Document Change Announcement

Standard Drawings

Electrical Qualification Criteria Updates

DCA2024SD-01

E-01

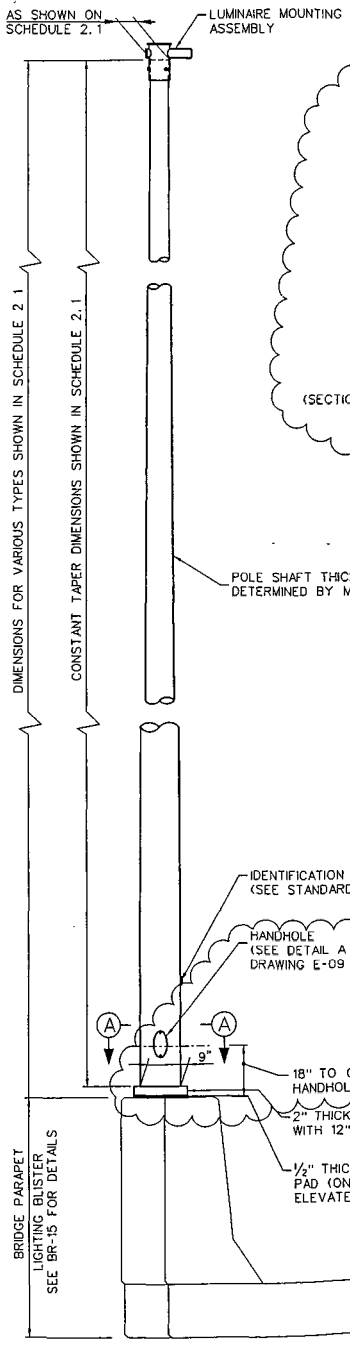
1	DIMENSION & LUMINAIRE TYPES	01/24
0	REISSUED DRAWING	09/21
REV.	DESCRIPTION	DATE

STANDARD DRAWING
E-02

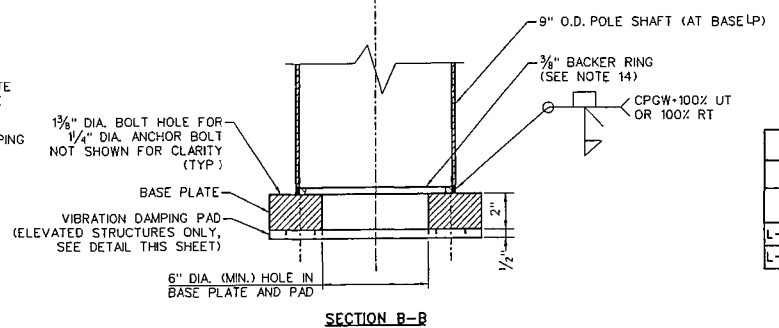
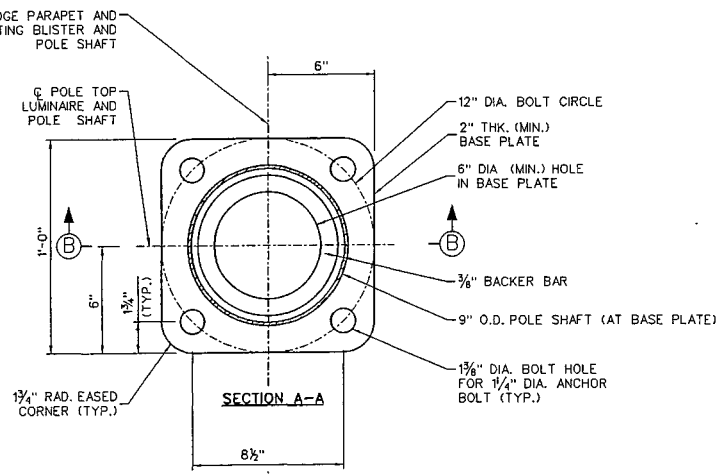
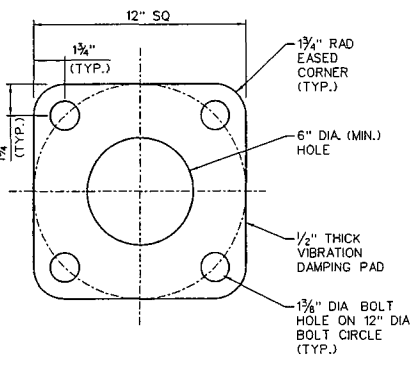
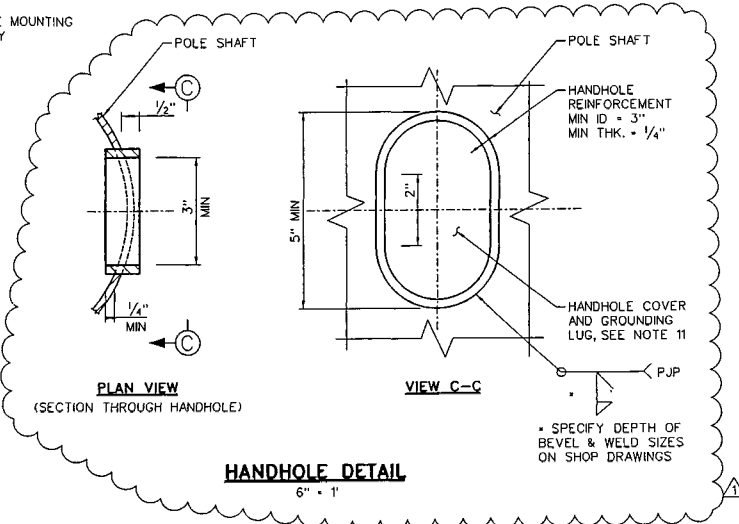
REV.	DESCRIPTION	DATE
1	UPDATED HANDHOLE & NOTE	01/24
0	REISSUED DRAWING	09/21

- A HANDHOLE IS REQUIRED ON ALL BRIDGE-MOUNTED LIGHTING STANDARDS AND SHALL BE LOCATED SUCH THAT THE VERTICAL CENTERLINE OF THE HANDHOLE IS 18" FROM TOP OF PARAPET. WHEN LOCATED BEHIND CHAIN LINK FENCE, THE BOTTOM OF THE HANDHOLE SHALL BE LOCATED ONE FOOT ABOVE THE FENCE. ATTACHMENT SCREWS SHALL BE COATED WITH AN APPROVED ANTI-SEIZE COMPOUND.

STANDARD DRAWING
E-04

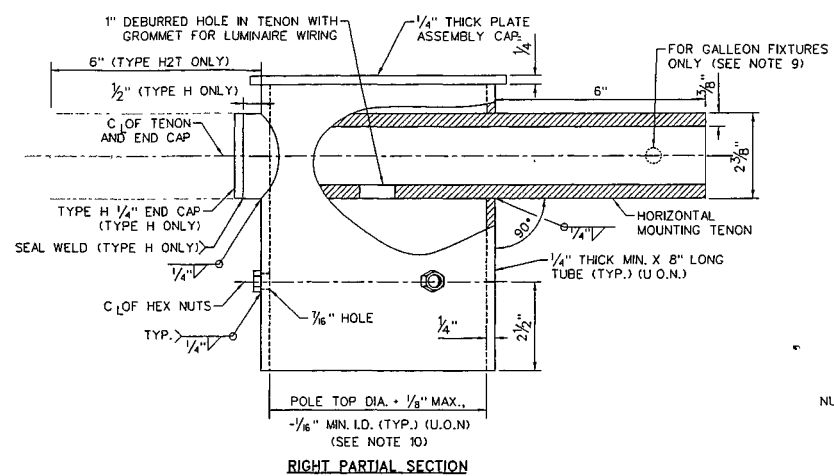
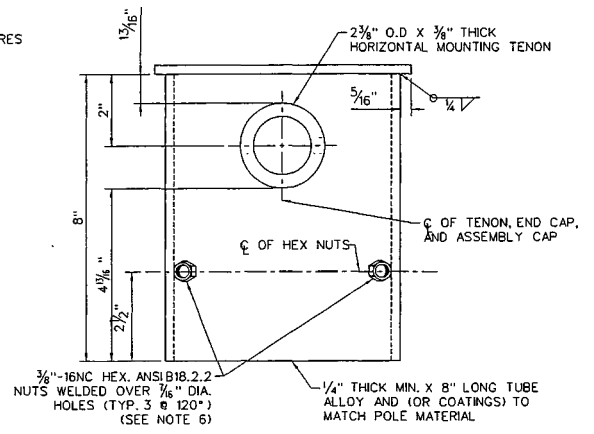
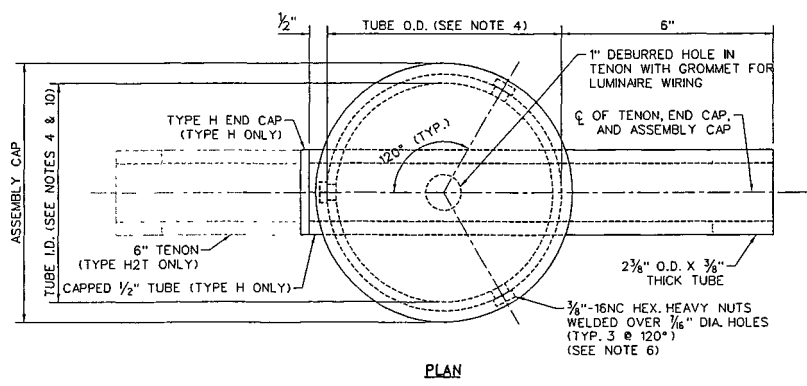
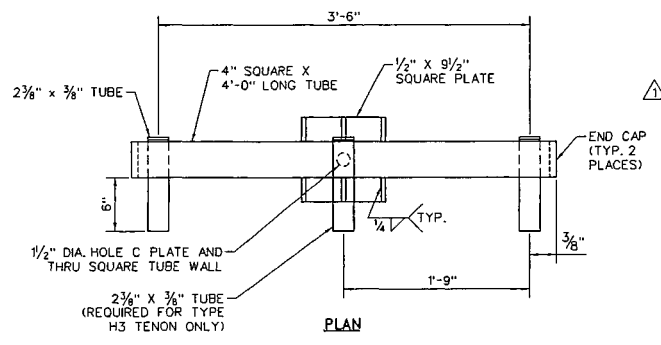
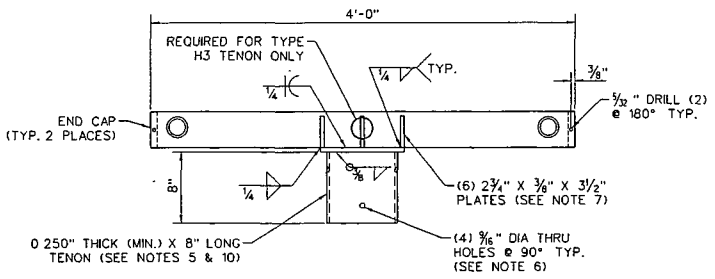
1	ADDED NOTE	01/24
0	REISSUED DRAWING	09/21
REV.	DESCRIPTION	DATE

- WHEN HORIZONTAL MOUNTING ADAPTERS ARE USED TO INSTALL THE GALLEON FIXTURE, A THROUGH BOLT SHALL BE INSTALLED TO SECURE MAST ARM ADAPTER AND TENON. TENON REQUIRES A HOLE FOR A 3/8"-16 STAINLESS STEEL HEX HEAD BOLT WITH LOCK WASHER AND DOUBLE NUT, LENGTH AS REQUIRED. THE TENON ADAPTER MAY BE MANUFACTURED WITH THIS HOLE OR THE HOLE MAY BE FIELD-DRILLED.

STANDARD DRAWING
E-05

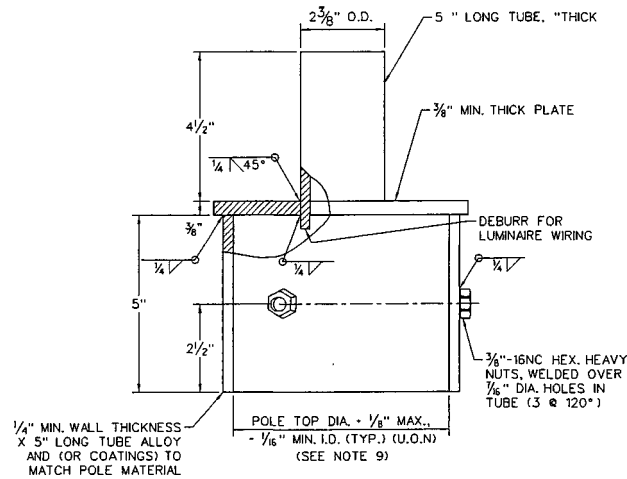
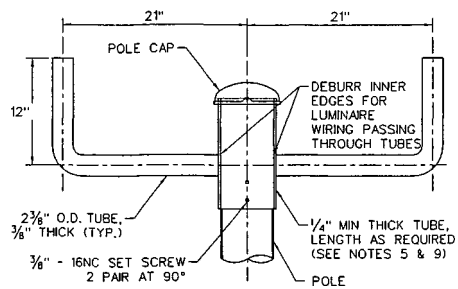
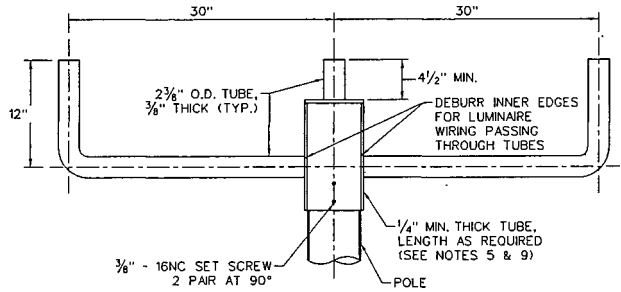
1	ADDED NOTE	01/24
0	REISSUED DRAWING	09/21
REV.	DESCRIPTION	DATE

STANDARD DRAWING
E-09

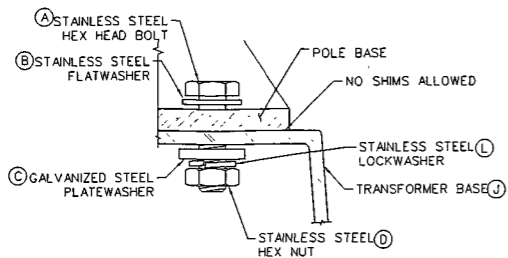
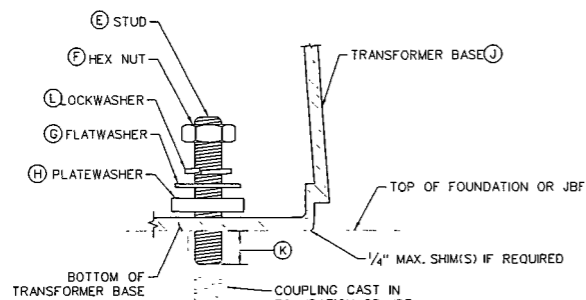
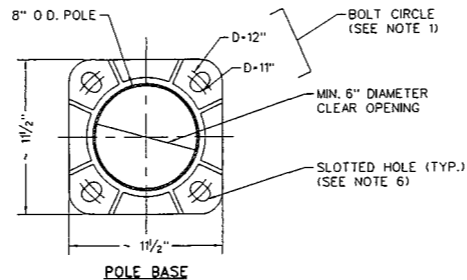
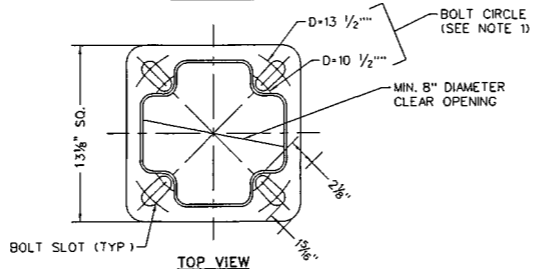
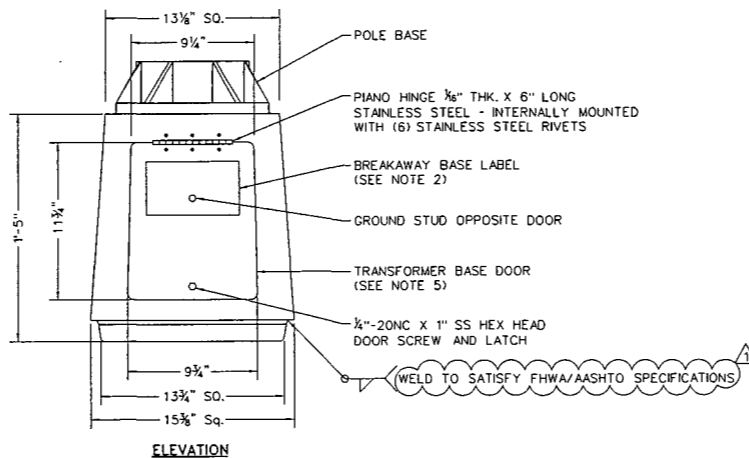
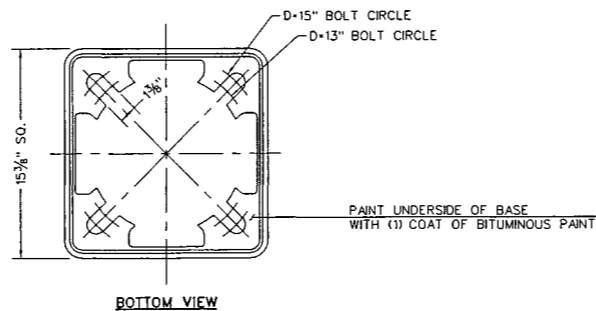
1	REVISED TRANSFORMER BASE WELD	01/24
0	REISSUED DRAWING	09/21
REV.	DESCRIPTION	DATE

CONCRETE BASE, TYPE LP

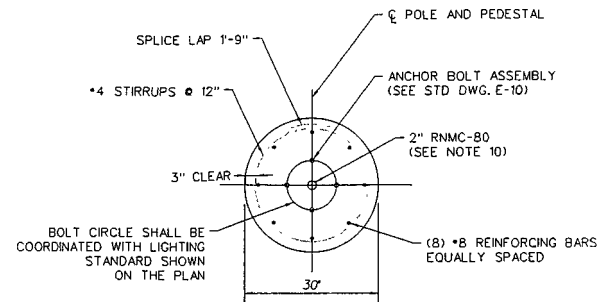
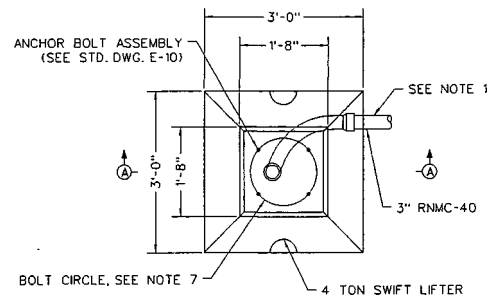
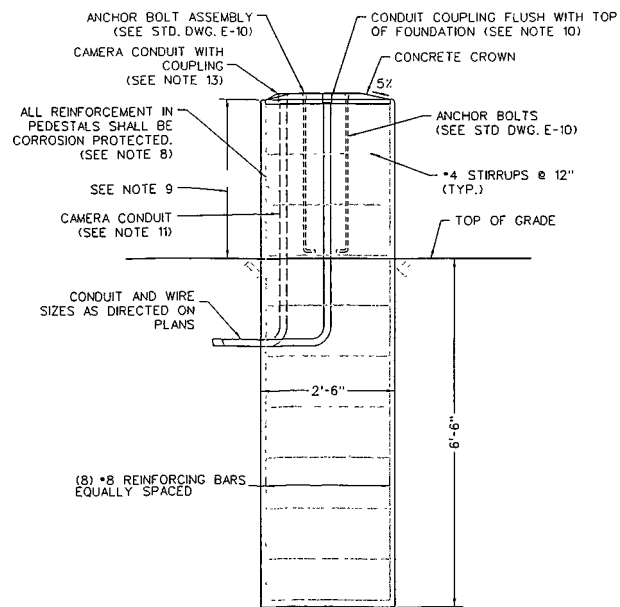
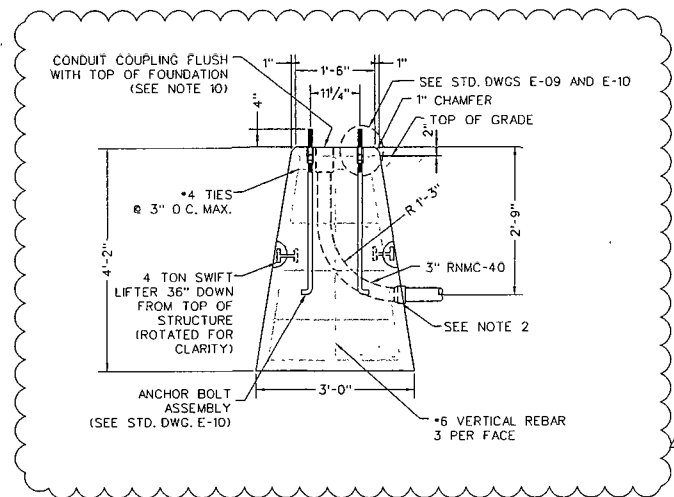
REV.	DESCRIPTION	DATE
1	UPDATED LIGHT POLE BASE LP	01/24
0	REISSUED DRAWING	09/21

STANDARD DRAWING
E-13

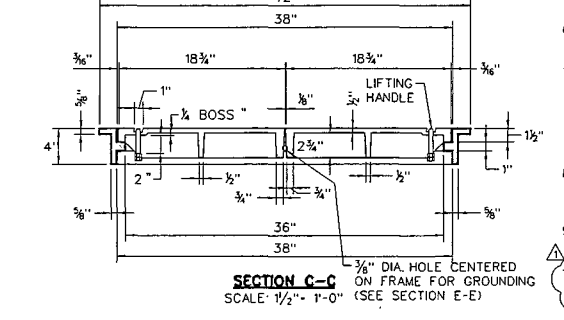
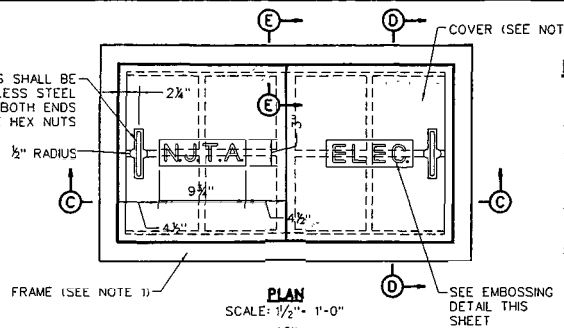
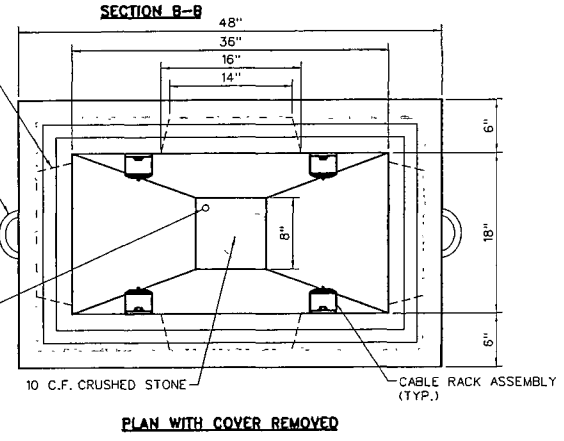
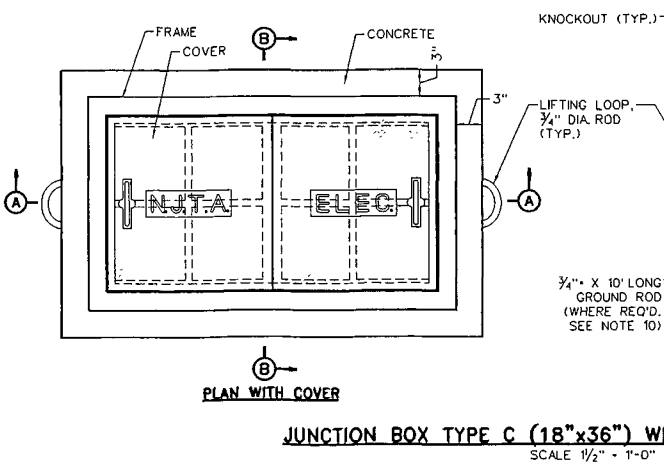
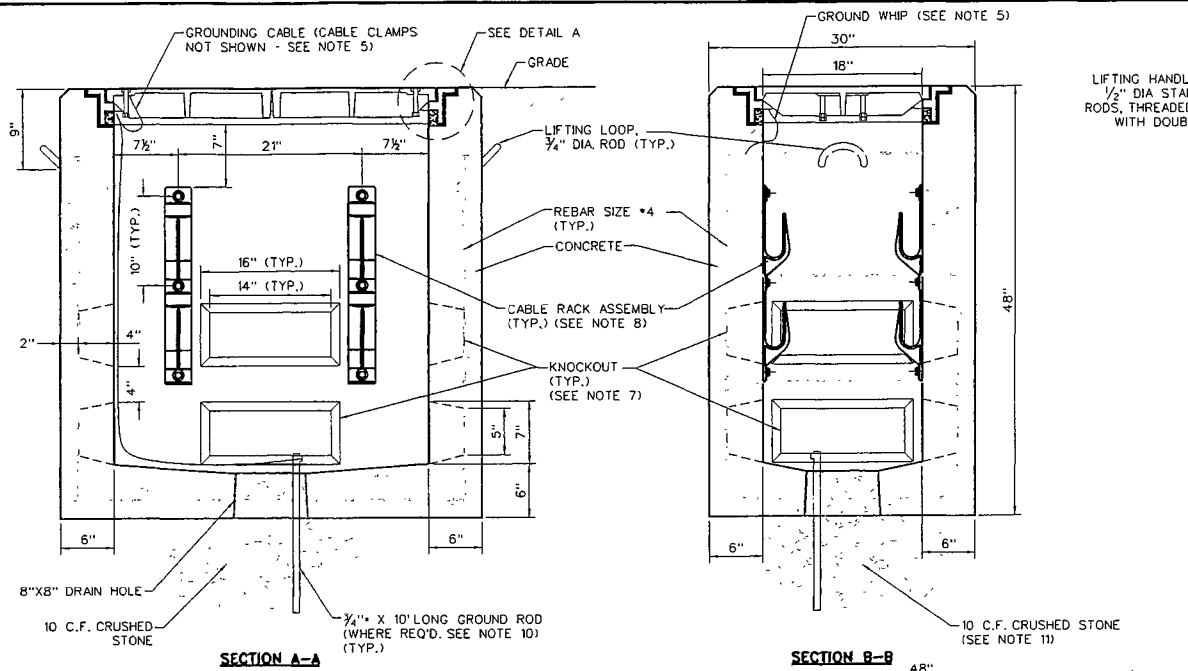
REV.	DESCRIPTION	DATE
1	ADDED ITS EMBOSING, EDIT NOTE	01/24
0	REISSUED DRAWING	09/21

STANDARD DRAWING
E-20

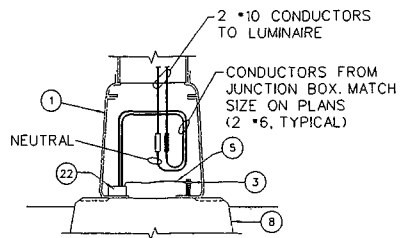
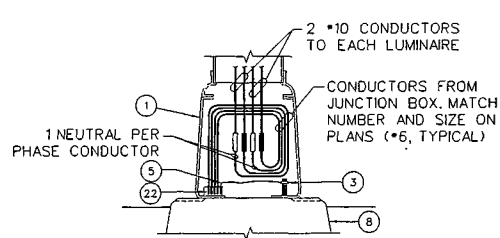
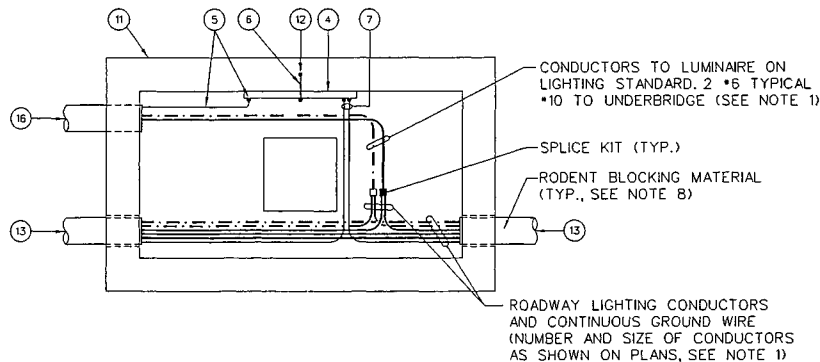
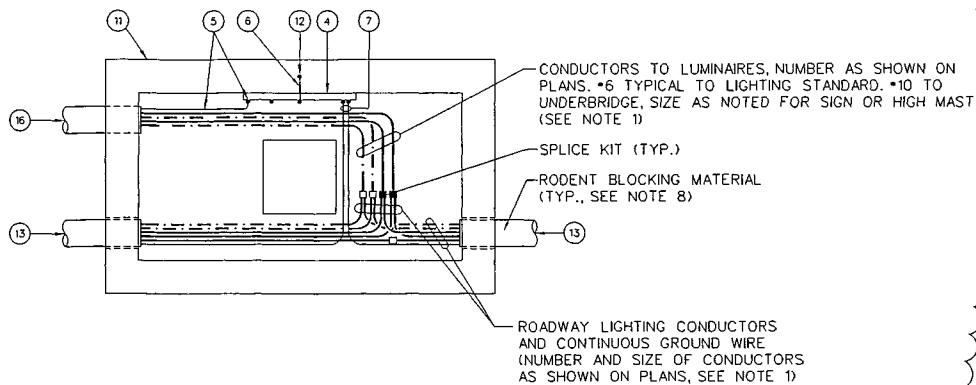
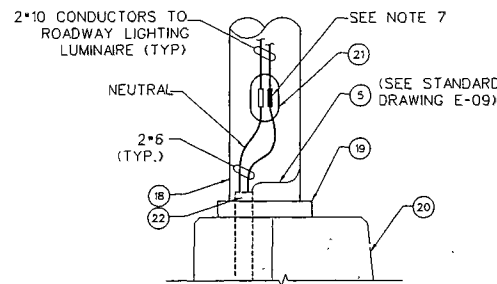
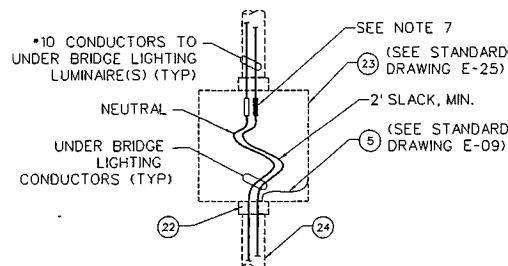
1	REVISED TYPICAL WIRING DETAILS	01/24
0	REISSUED DRAWING	09/21
REV.	DESCRIPTION	DATE
